**Before the
FEDERAL COMMUNICATIONS COMMISSION
Washington, D.C. 20554**

_____)	
Application of)	
VIASAT, INC.)	Call Sign: S2985
For Modification of the Viasat)	
Non-Geostationary Orbit Satellite System)	File No. SAT-MPL-20200526-00056
Using Ka- and V-Band Frequencies)	
_____)

PETITION TO DENY OR DEFER OF SPACE EXPLORATION HOLDINGS, LLC

PETITION TO DENY OR DEFER OF SPACE EXPLORATION HOLDINGS, LLC

Figure 17 from Viasat Amendment: Average Number of Potentially Active VIASAT-NGSO Satellites Above the Horizon (In bands with EPFD limits)¹⁴

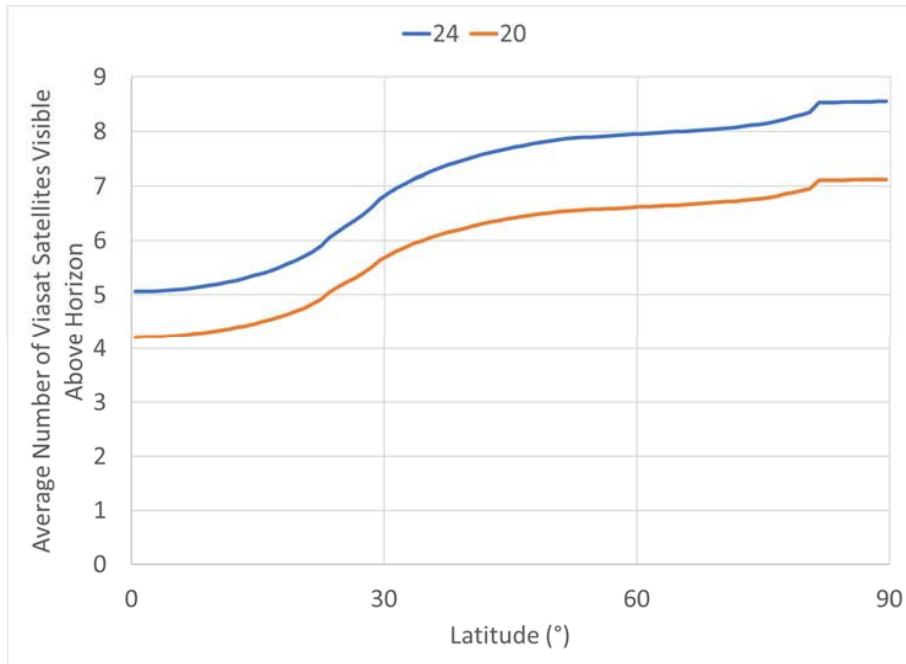
In granting Viasat’s application, the Commission endorsed this analysis.

[T]he fact that the number of satellites proposed is reduced, the altitude of the proposed orbits remains the same, and the frequencies requested are unchanged mean that the number of potential interference events between ViaSat’s proposed satellites and other satellites being proposed in the same processing rounds is likely to be decreased and the number of times constellations will be required to reduce spectrum will also likely be smaller. *As both ViaSat and SpaceX assert, and we agree, these changes decrease the potential for interference*, rather than increase it.¹⁵

Yet in its current application, Viasat takes precisely the opposite view. Indeed, it proudly proclaims that its proposed modification would dramatically *increase* the number of satellites in view from any point within the continental United States, as illustrated by the figure below taken from the application.¹⁶

Figure 1 from Viasat Modification Technical Annex

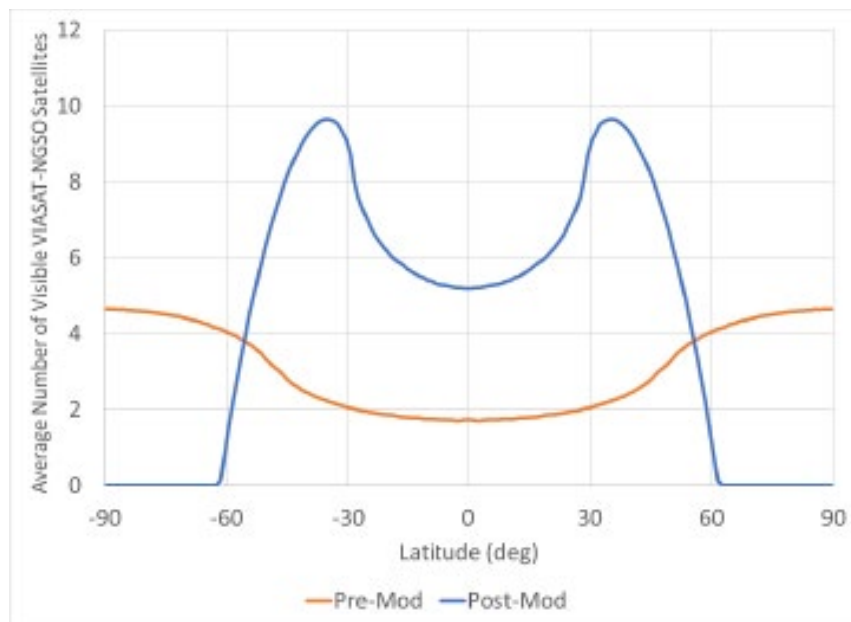
Nonetheless, Viasat now claims that these additional satellites will not create the potential for additional interference because they provide “increased flexibility to employ satellite diversity as a mitigation technique more often than otherwise would have been possible with its previous design.”¹⁷

Whether or not additional satellites *could* allow Viasat to ameliorate the impact of in-line events through increased satellite diversity in theory, the impact of in-line events *in reality* depends on other operational practices.¹⁸ But when it comes to actual practice, Viasat provides scant detail. Not only has Viasat offered no explanation of how its operational practices will take advantage of this flexibility to reduce interference, it has made no commitment to do so. On the contrary, Viasat’s continued opposition to sharing beam-pointing information¹⁹ means that other operators

Figure 1. Geometric In-Line Events Before and After Proposed Viasat Modification

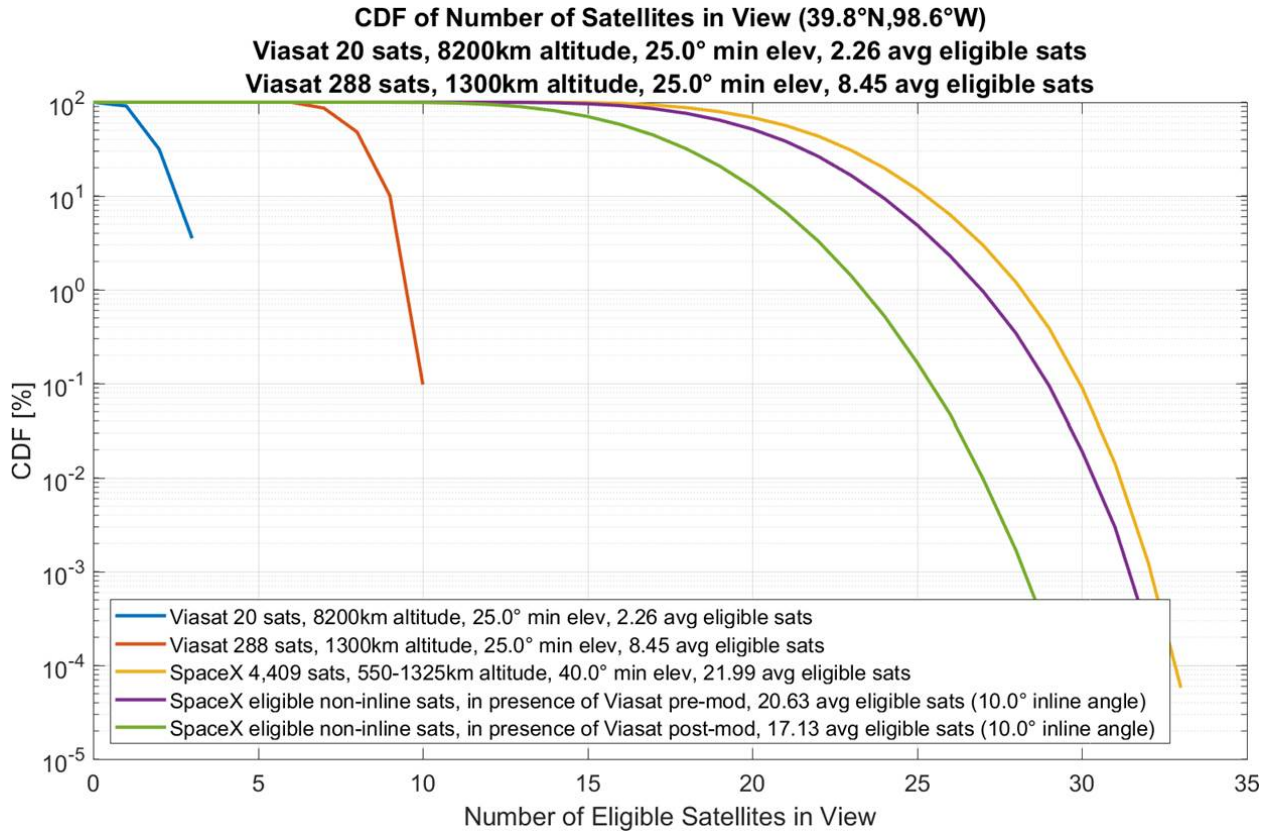
To illustrate this principle, Figure 1 below shows the effect of Viasat's proposed modification on the number of eligible satellites in view for the Viasat and SpaceX NGSO systems from the location used by Viasat in its I/N analysis, assuming a 10-degree separation angle. As the figure shows, the introduction of hundreds of additional Viasat satellites reduces the average

number of eligible SpaceX satellites from 20.63 to 17.13. In other words, the average number of SpaceX satellites experiencing a geometric in-line event with a Viasat satellite is *more than three times higher*, jumping from 1.36 to 4.86.

As noted above, Viasat argues that the additional satellites in view will provide the flexibility to choose satellites that are not in-line with other NGSO systems and thereby avoid interference. But the only way to ensure that Viasat’s proposed modification would not substantially reduce the ability of other NGSO FSS systems to use shared spectrum would be if Viasat were to take full responsibility for avoiding interference by, for example, using beam pointing information from the victim system(s) to avoid interference events. If Viasat’s application were considered in a new processing round, the rights of existing NGSO FSS licensees would presumptively be protected in this way – a requirement that Viasat could use its new-found

satellite diversity to satisfy. Accordingly, the Commission should defer consideration of this modification to a later processing round.

Figure 2. Ka-Band Uplink Interference to Viasat's NGSO System

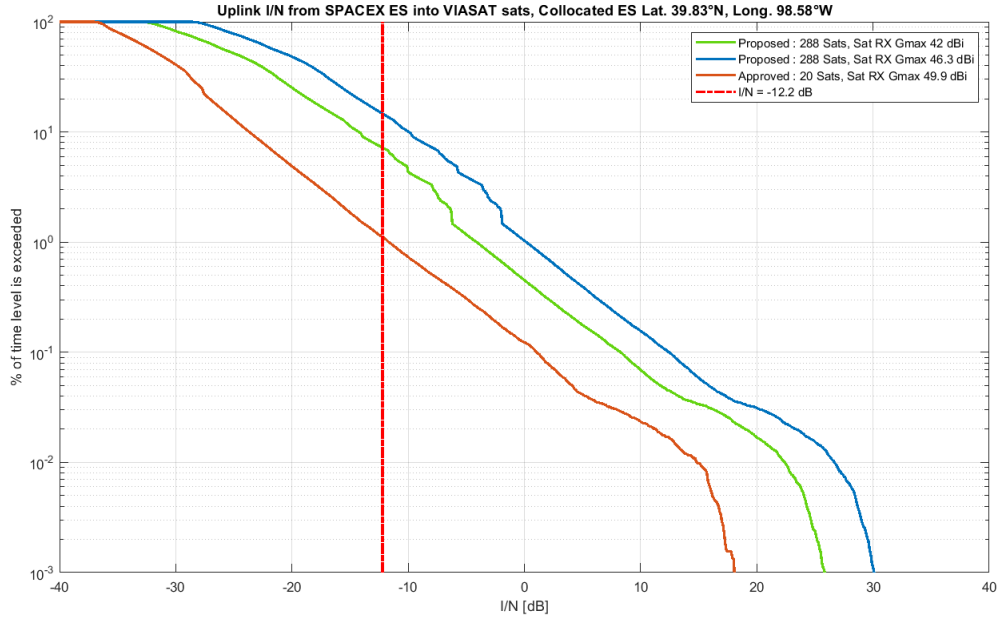
As noted above, Viasat did not consider the effect of its proposed modification on its own susceptibility to interference. Because other NGSO FSS operators will be required to split spectrum with Viasat’s modified system at a specified interference level, their systems could be adversely affected by Viasat’s own susceptibility to interference. This is particularly troublesome on the uplink, where reducing operating altitude by 6,900 km reduces the path loss and effectively increases the EIRP of competing uplink signals of other systems into Viasat’s satellite receive antenna by approximately 16 dB. By comparison, the satellite G/T in the Viasat Modification has been reduced by just 3.6 dB or 7.9 dB for high gain and low gain antennas, respectively. Figures 2 and 3 below show the dramatic effect of these changes on the interference experienced by Viasat’s modified system in the Ka-band and V-band, respectively.

Accordingly, if the Commission grants the modification in any form, it must impose a condition requiring Viasat to accept any additional interference to its uplinks from other NGSO systems authorized in the 2016 Round resulting from this modification compared to its current authorization.

Figure 4. Viasat Ka-Band Downlink Interference to SpaceX

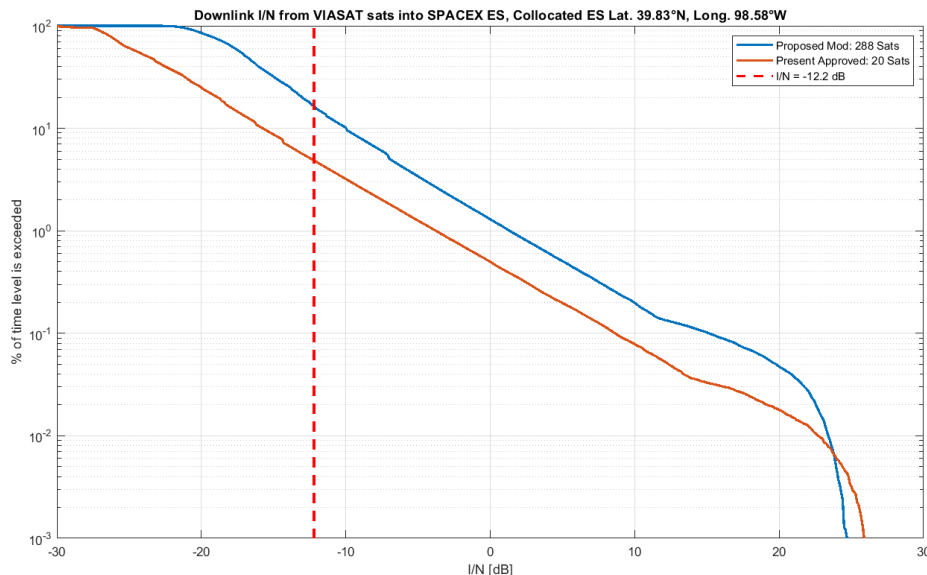
To determine the effect of the proposed modification on the downlinks of SpaceX's authorized system, SpaceX performed an I/N CDF analysis like the one provided by Viasat. In Viasat's analysis, "[o]perational EPFD spectral densities have been used to model the VIASAT-

NGSO transmitters based on the current grant and on the proposed modification.”²³ Accordingly, for its simulation, SpaceX incorporated information from the EPFD data files submitted by Viasat to the ITU for its current and proposed systems. Among other things, the DREBBELSAT filings indicate a 2 dB decrease in Ka-band PFD (from -131.3 dBW/m²/40kHz for the current MEO system to -133.4 dBW/m²/40kHz for the proposed LEO system) and a 4 dB increase in V-band PFD (from -131.3 dBW/m²/40kHz for the current MEO system to -127.2 dBW/m²/40kHz for the proposed LEO system). In addition, these ITU filings indicate that the number of co-frequency beams per spot (the “Nco” value) in both the Ka- and V-bands would increase from 2 in the current MEO system to 8 in the proposed LEO system. SpaceX also used the assumptions stated in Viasat’s analysis.²⁴ The results are presented in Figures 4 and 5 below for Ka-band and V-band, respectively.

As this analysis clearly shows, contrary to Viasat’s assertions, its modified system would create significantly more potential interference to SpaceX’s system than the system Viasat is currently authorized to deploy – even assuming a decrease in Ka-band PFD for the proposed LEO system. It would increase minimum I/N levels and increase the probability of I/N levels requiring band splitting in Ka-band by 240%. Accordingly, the Commission can only consider this application as part of a later processing round.²⁵ In this case, Viasat filed its application within the window for participation in the Ku/Ka-band NGSO processing round that was recently initiated. Its requests with respect to V-band spectrum, however, should initiate a new processing round in that band.

Figure 3 from Viasat Modification Technical Annex

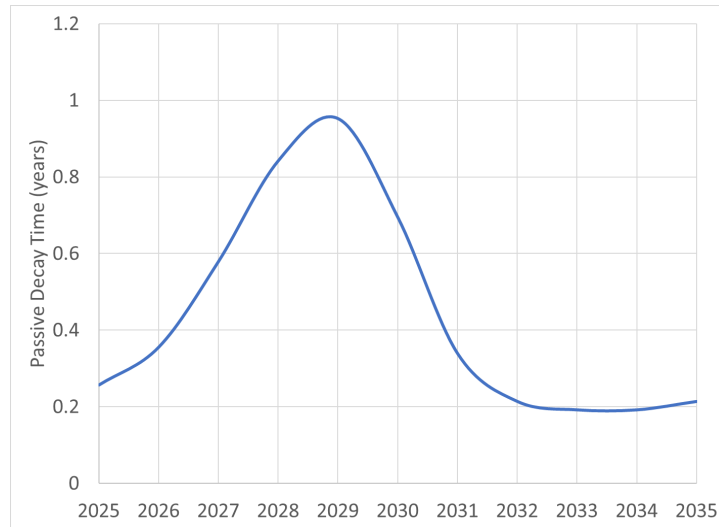
This information can be used with other data provided by Viasat to determine the area-to-mass ratio (“A:M”) assumed for each Viasat satellite. Viasat used NASA’s Debris Assessment Software (“DAS”) to generate the following plot of passive decay time against mission end year⁴¹:

With the information determined above about the characteristics of Viasat’s intended passive decay orbit, DAS can be used to determine the A:M.⁴² Figure 6 below shows the best fit, which uses A:M of 0.10 m²/kg to achieve results virtually identical to those presented by Viasat.⁴³

Figure 2 from Viasat Modification Technical Annex

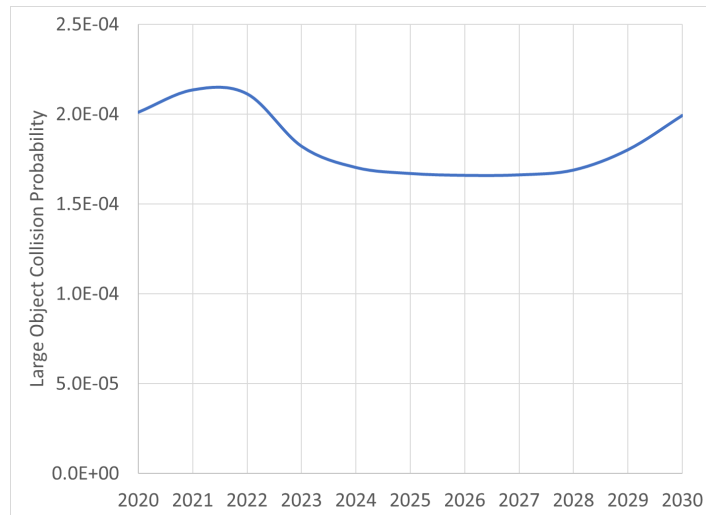
The A:M, in turn, can be used with another DAS plot provided by Viasat to determine mission duration. Below is the plot provided in the application of collision probability risk vs. launch year.⁴⁴

Viasat states in the Schedule S accompanying its modification application that its spacecraft will have an estimated lifetime of fifteen years. However, as shown in Figure 7, using that value in the DAS analysis results in a curve that does not correspond to the shape of the one provided by Viasat.

Figure 7. DAS-Generated Attempts to Recreate Viasat Collision Risk Curve

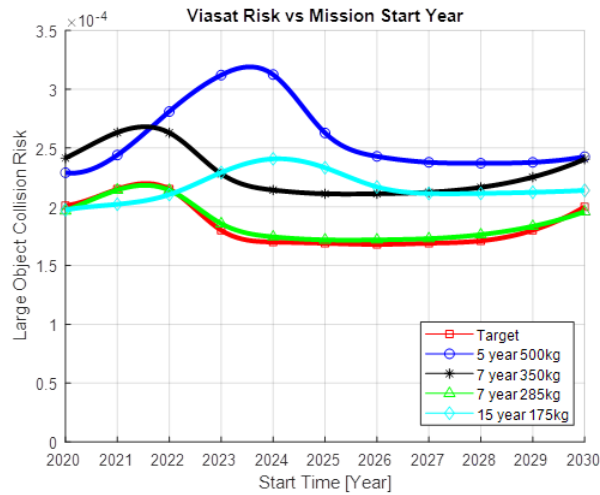
Using a value of five years does not result in a match either. Assuming a seven-year mission duration, however, results in a curve shape that very closely replicates the one submitted by Viasat. (Since we do not yet have a value for the mass of a Viasat spacecraft, we use several values in the 150-600 kg range to generate a curve for consideration.)

Figure 8. Fully Recreated DAS Collision Risk Plot

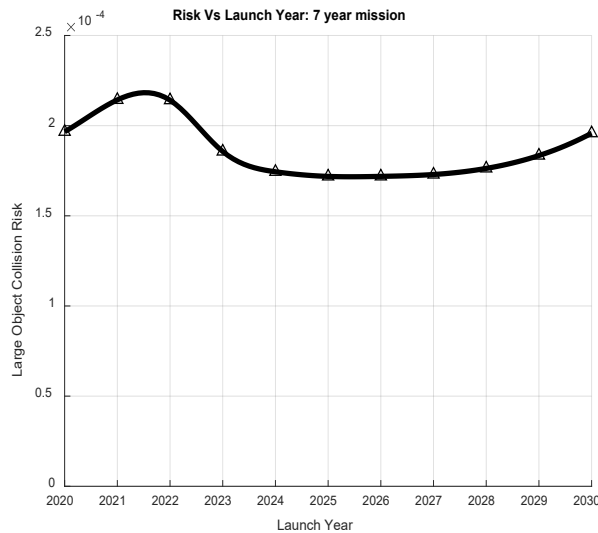
With the mission duration deduced, satellite mass is the only parameter left to tune the plot. As shown in Figure 8 below, using a mass of 285 kg with a mission duration of seven years results in a DAS output that is nearly identical to Figure 2 from Viasat’s filing.

Having used DAS to deduce the values used by Viasat, we can now evaluate Viasat’s orbital debris analysis. In order to do so, we first determine the characteristics of those Viasat satellites that fail in operational orbit at 1,300 km altitude – something Viasat obscured by providing only information on passive deorbit *assuming* active removal from operational orbit had already been accomplished. DAS will only report up to 100 years of decay time and will zero out any risk after 2130. However, this limitation can be overcome to reach a much more accurate assessment by recursively feeding the final altitude at the end of each 100-year analysis into a new DAS analysis until the satellite reenters the atmosphere. Table 1 below shows the decay time and risk of collision with a large object for a Viasat in-orbit failure under each of these approaches.
